Morgan and Morecambe Offshore Wind Farms: Transmission Assets [Ref. EN020028] - Deadline 1: Response to the Action Points of the ExA arising from Issue Specific Hearing 1 (Our client: BAE Systems [Unique Reference: 20053944])

Applicant's Response to Rule 17 Letter

Figure 4-2: Ben My Chree Transits during 2022 between Heysham and Douglas next to West of Duddon Sands.

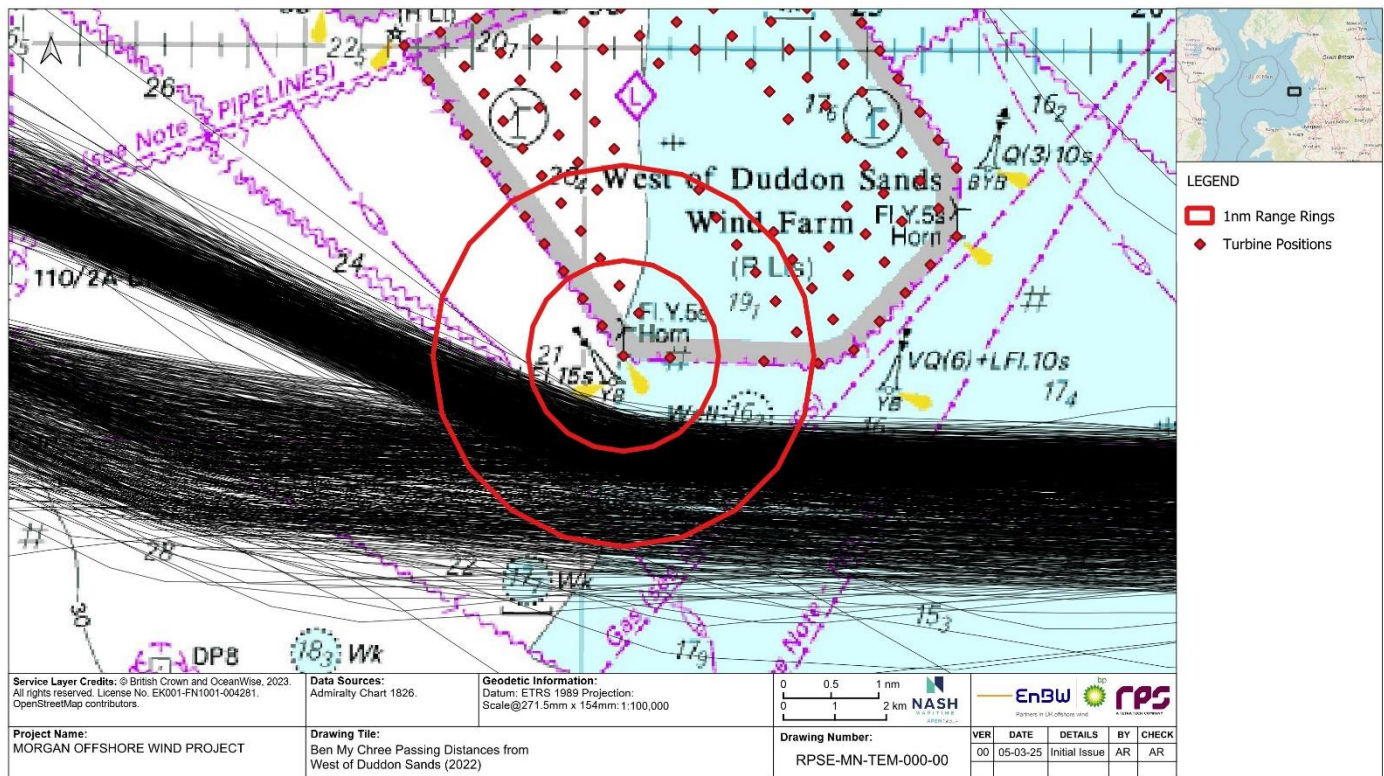
- The Applicant also notes that 2 nm passing distance from the offshore wind farms is inconsistent with typical operational behaviour. For example, more than 80% of all transits of the Ben My Chree during 2022 between Heysham and Douglas passed within 1.5 nm of the most south-westerly turbine of West of Duddon Sands, and 52% passing within 1 nm (Figure 4.2).

Figure 5-1 Exact measurements from respective boundary set backs

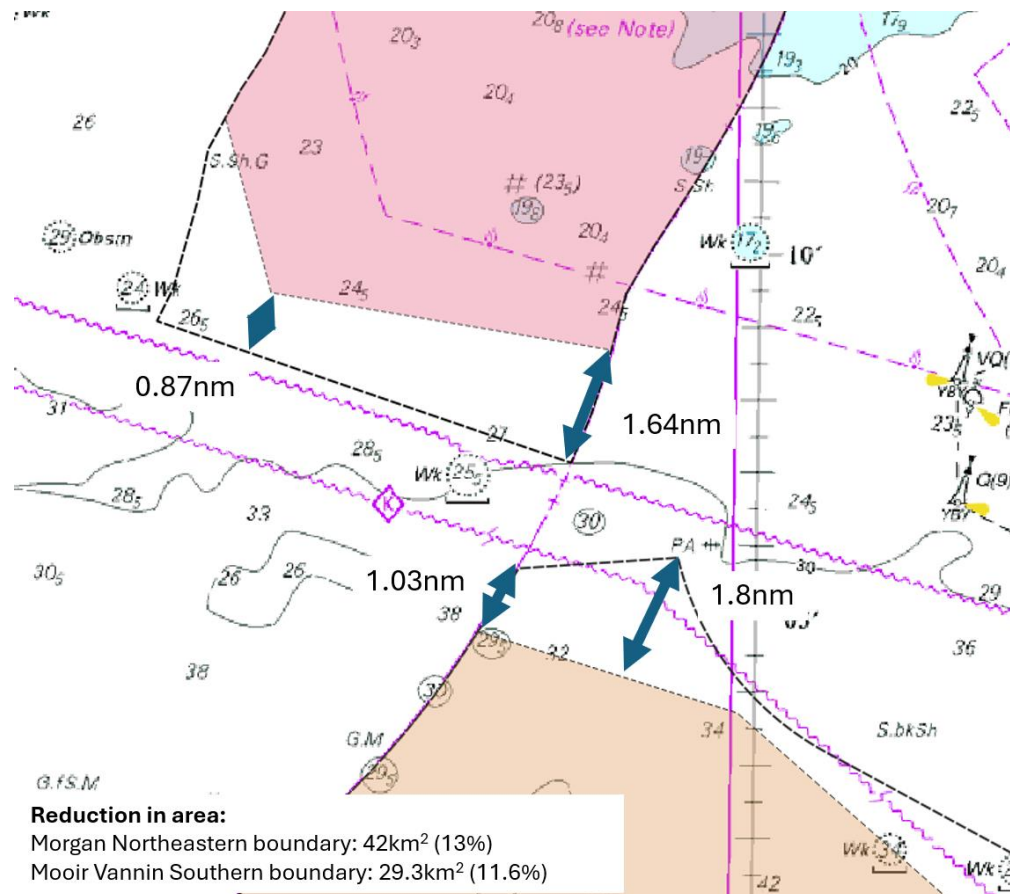
5.1.2.6 MVOWFL in its Deadline 5 submission (REP5-075) included comment on the design refinement for each of the Morgan Generation Assets and the Moir Vannin Offshore Wind Farm to support a submission that there had been a greater reduction in the developable area of the Moir Vannin Offshore Wind Farm. The information included in MVOWFL's submission does not present the full picture, which the Applicant considers it important to clarify as a point of fact, and has detailed this in Table 5.1 and Figure 5-1 below. The Applicant reduced a greater proportion of array area directly relevant to the gap between the Morgan Generation Assets and the Moir Vannin Offshore Wind Farm, than MVOWFL presented in their Deadline 5 submission (REP5-075). Further the Applicant has also collectively mitigated for a quarter of the total developable area (25-26%) and any further reduction would lead to considerable capacity loss. The current boundary concessions for both the Applicant and MVOWFL have proven to be ALARP and there should be no further requirement for any increased separation.
